McGREGOR LEGERE & STEVENS

October 16, 2024

**RE: Request for Superseding Order of Conditions
DEP File No. 246-0785
Applicant: Sovereign Builders, Inc.
Location: 8 View Avenue and 56 Northern Avenue, Northampton, MA**

Mound AT center
 OF SYSTEM = 3,33 Feet

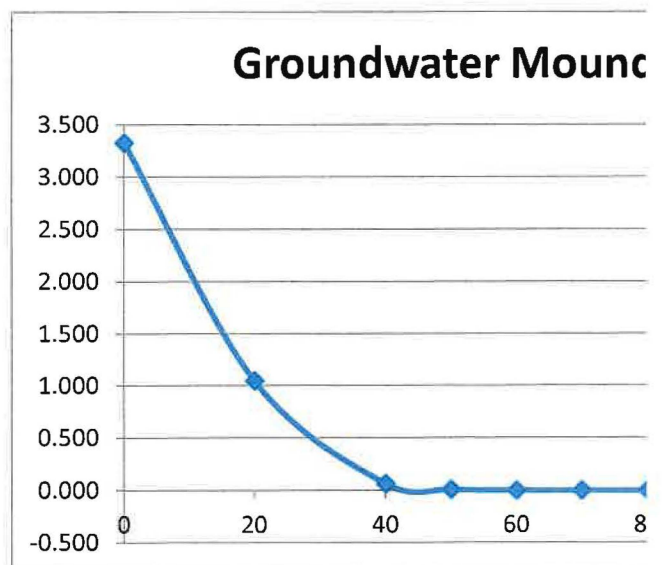
If these errors in data are corrected, the groundwater mounding analysis would predict a mound at the center of the infiltration system of 3.3 feet. The Applicant's model only shows a mound of 1.5 feet. This mound of 3.3 feet will extend into the infiltration system. If a mound of 3.3 develops, SIS #2 will cease to function for a period of time.¹⁸

While a groundwater mounding analysis for SIS #2 has been provided in the most recent submittal, the analysis is based on questionable data assumptions required for the Hantush Spread Sheet used.

Finally, the infiltration duration period should be set to one day, as the model is simulating the response to a 24-hour storm.
